Catawba Nuclear Station COLR

Catawba Unit 2 Cycle ~~5~~⁶

Core Operating Limits Report

November 22, 1991

Figure 2

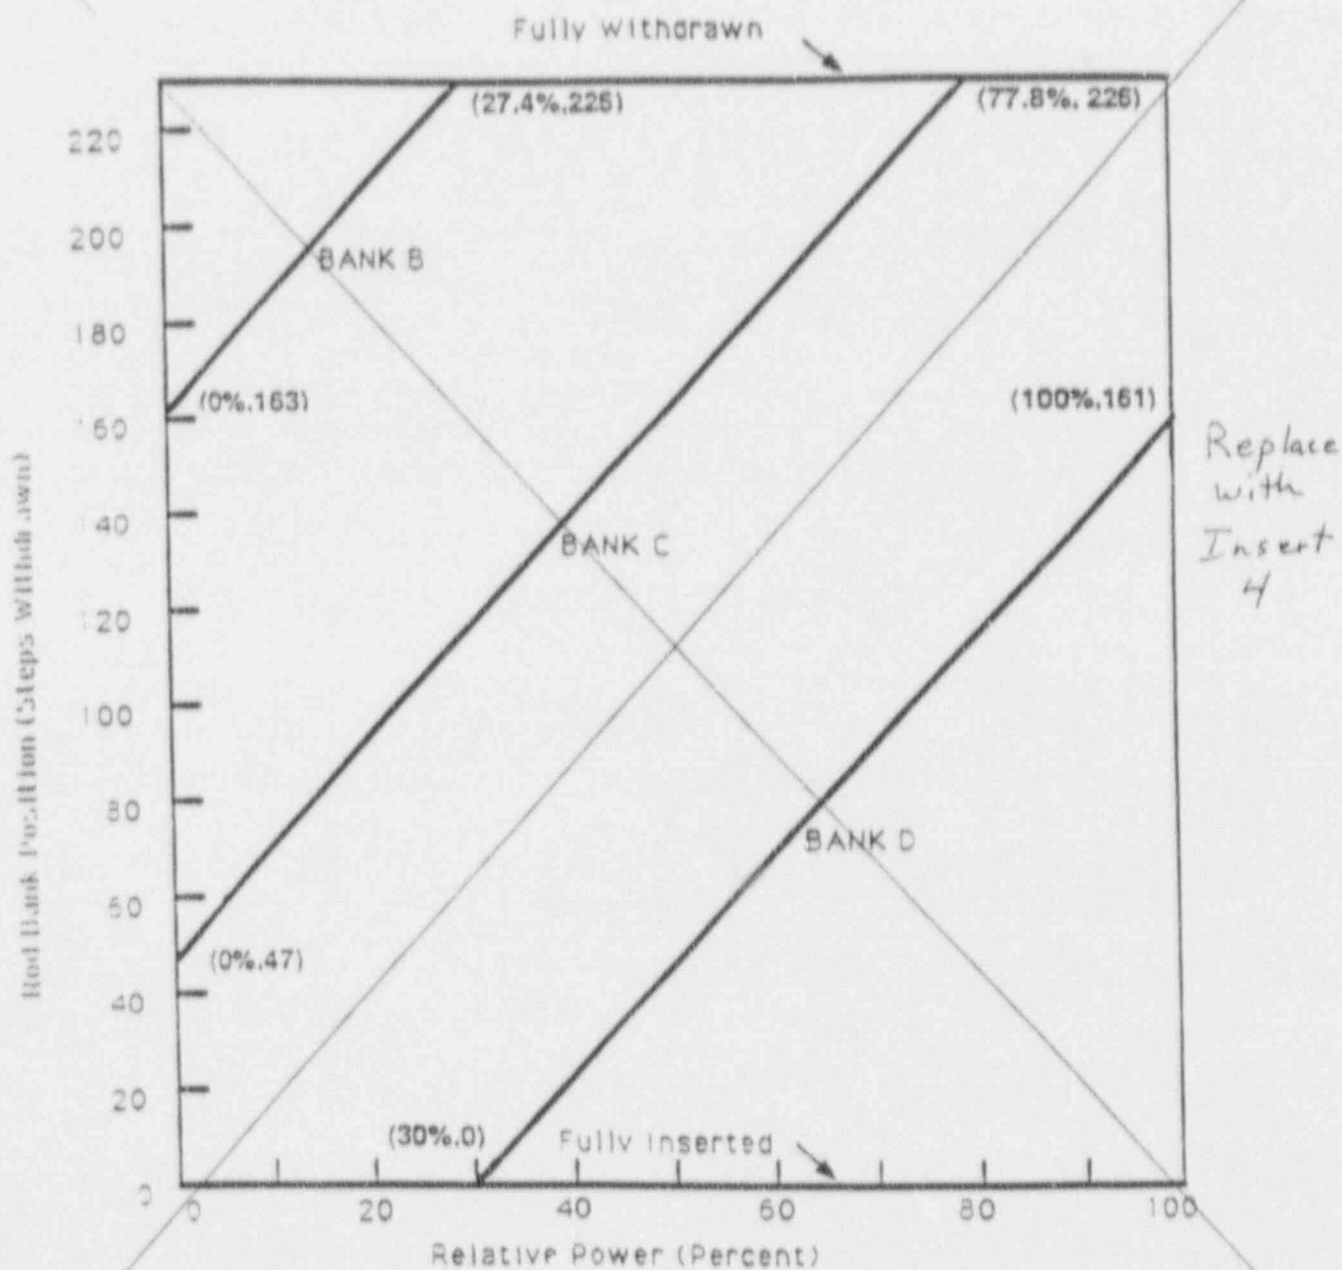
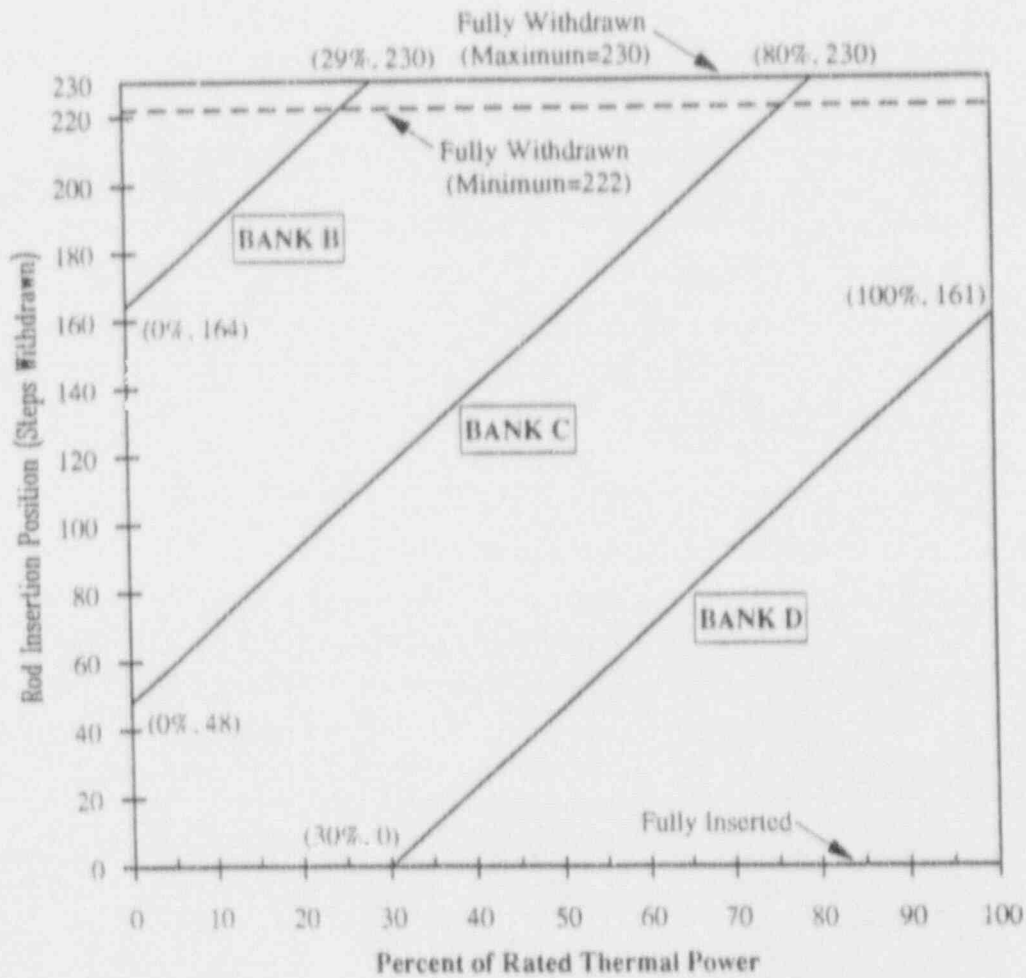
2.3.1 The control rod banks shall be limited in physical insertion as shown in Figure 2.

Insert 4

Control Rod Bank Insertion Limits Versus Percent of Rated Thermal Power

Figure 4

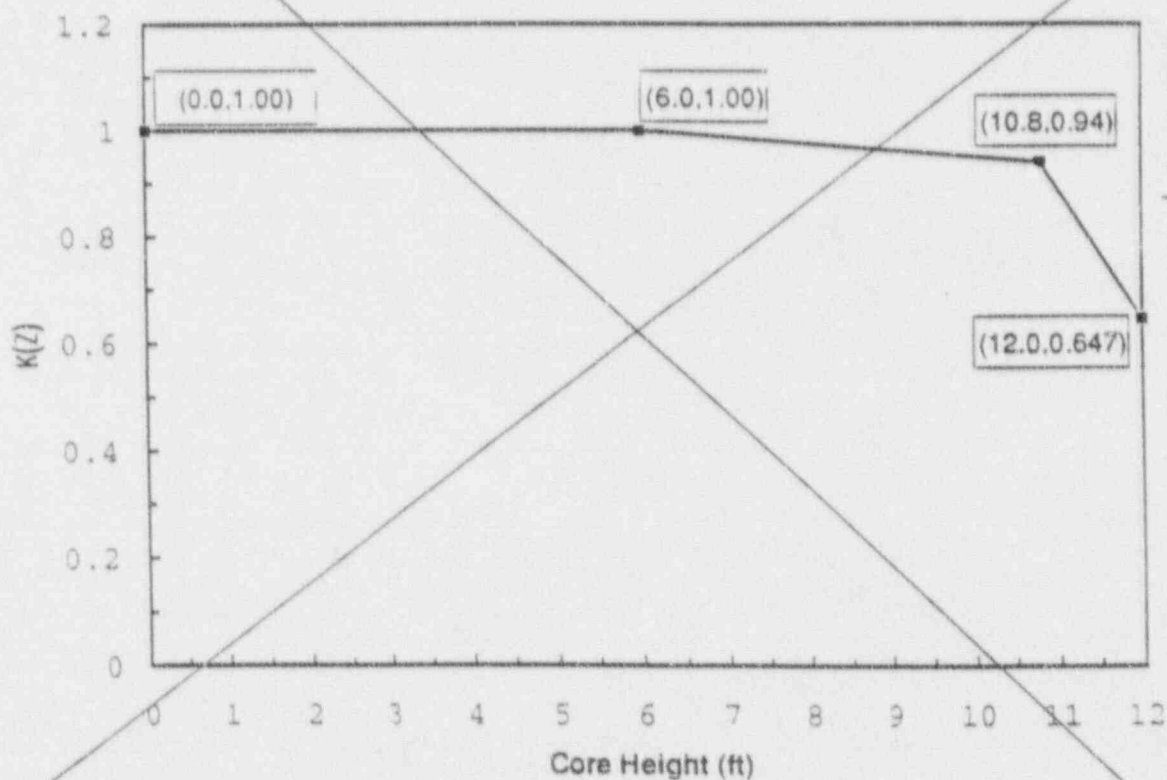
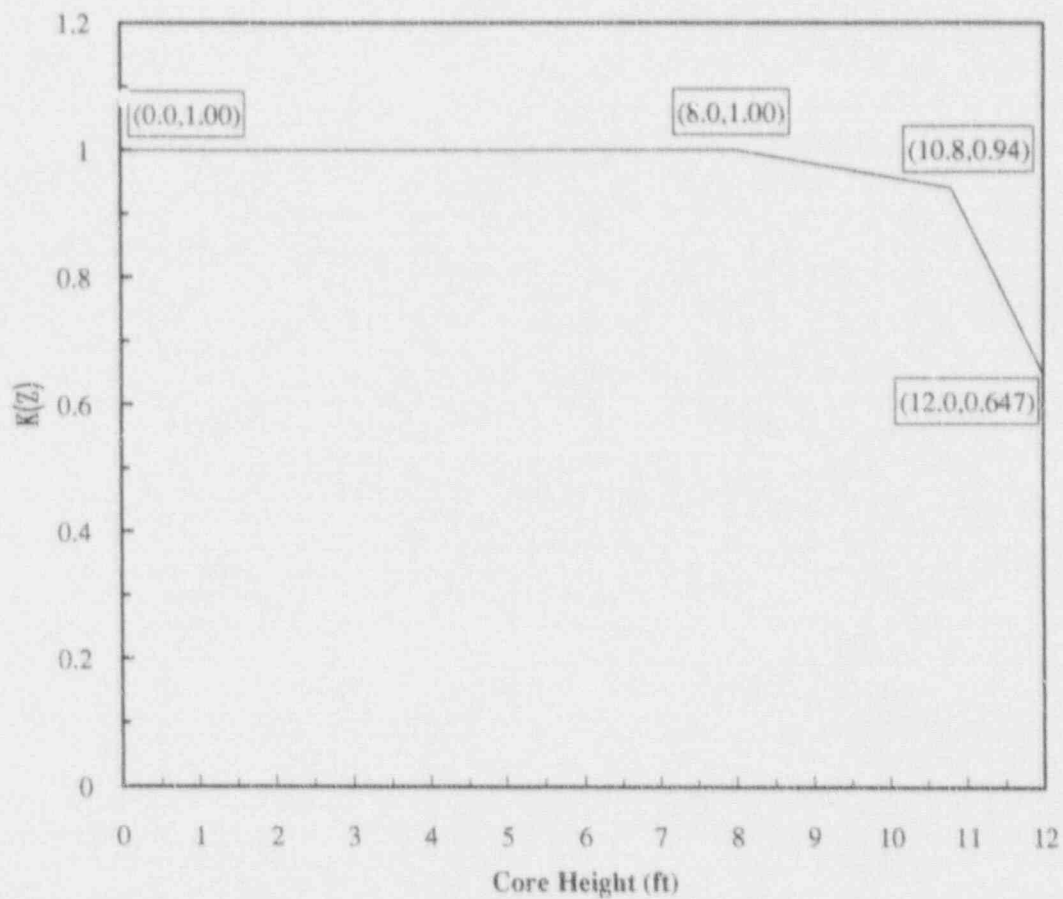
2.5.2 $K(Z)$ is provided in Figure 4 for Mark-BW fuel.

Insert 6

$K(Z)$, Normalized $F_Q(X,Y,Z)$ as a Function of Core Height for Mk-BW Fuel

Figure 5

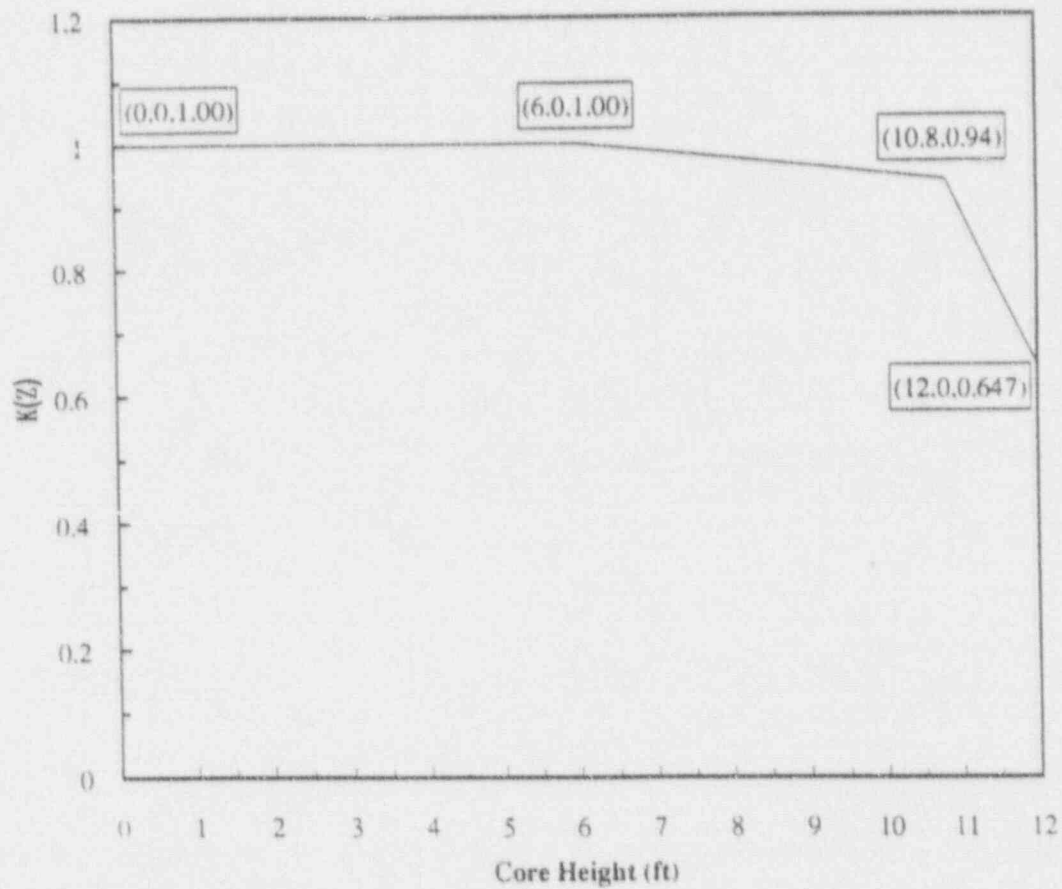
2.5.3 $K(Z)$ is provided in Figure 5 for OFA fuel.

Insert 6 - continued

$K(Z)$. Normalized $F_Q(X,Y,Z)$ as a Function of Core Height for OFA Fuel
